**ERDC/CRREL TR-00-13**

# **Assessment of Millennium Pipeline Project Lake Erie Crossing**

**Ice Scour, Sediment Sampling, and Turbidity Modeling**

Prepared for  
MILLENNIUM PIPELINE COMPANY

Figure 6.3. Progression of scouring ice keel-trench interaction.

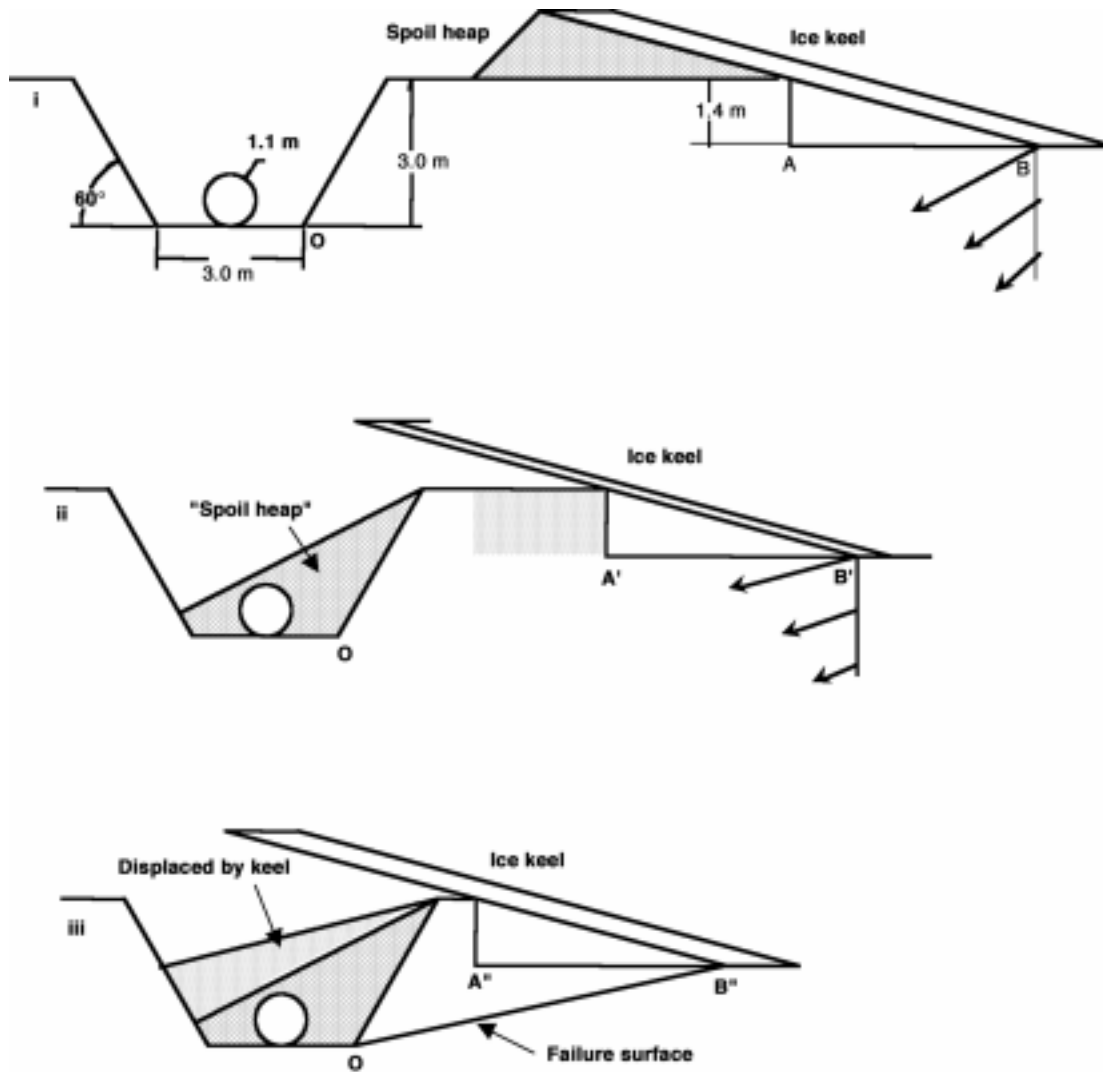
2. *The questions raised in the June 21, 1999 letter from OPE, Inc., to Mr. Heino Prah (National Fuel 2000) regarding the use of a two-dimensional rather than a three-dimensional analysis should be addressed in greater detail. In the September 1999 C-CORE Contract Report “Comparison of Lake Erie and Northstar Pipeline Designs for Ice Scour” (C-CORE 1999b) there is a short description stating that the ice scour process was simplified as a two-dimensional problem... “and tabulation of the number of degrees of freedom of the pipe finite elements of both the C-CORE and Northstar analyses.” It appears that the Northstar analysis used a three-dimensional approach, yet this is not discussed. We would appreciate clarification of this. Also, what are the consequences of using a 2-D rather than 3-D analysis?*

An ice keel with an attack angle of 15-degree scouring to a depth of 1.4 m (4.59 ft) and a width of 14 m (45.9 ft) is considered as shown in Figure 6.3i. This

The sub-gouge deformations are assessed from the PRISE program as shown by Woodworth-Lynas et al. (1996). The free-field sub-scour soil displacements accumulate from points A' to B' i) of Figure 6.3. The sub-scour displacement vectors are shown at three elevations under point B'. At the pipe spring-line elevation, the deformation vector magnitude is 6.2 ft. It should be noted that the free-field horizontal component is 5.1 ft, which is a very large percentage (82%) of the total deformation. This percentage increases significantly as the vertical deformation component is reduced through interaction with the trench and its infill.

**CRREL:** The response clarifies the use of a two-dimensional horizontal-loading analysis via a convincing qualitative argument. It also clarifies the conservatism built into the analysis arising from the analysis' assumption that the free-field horizontal deformation governs the pipe loading.
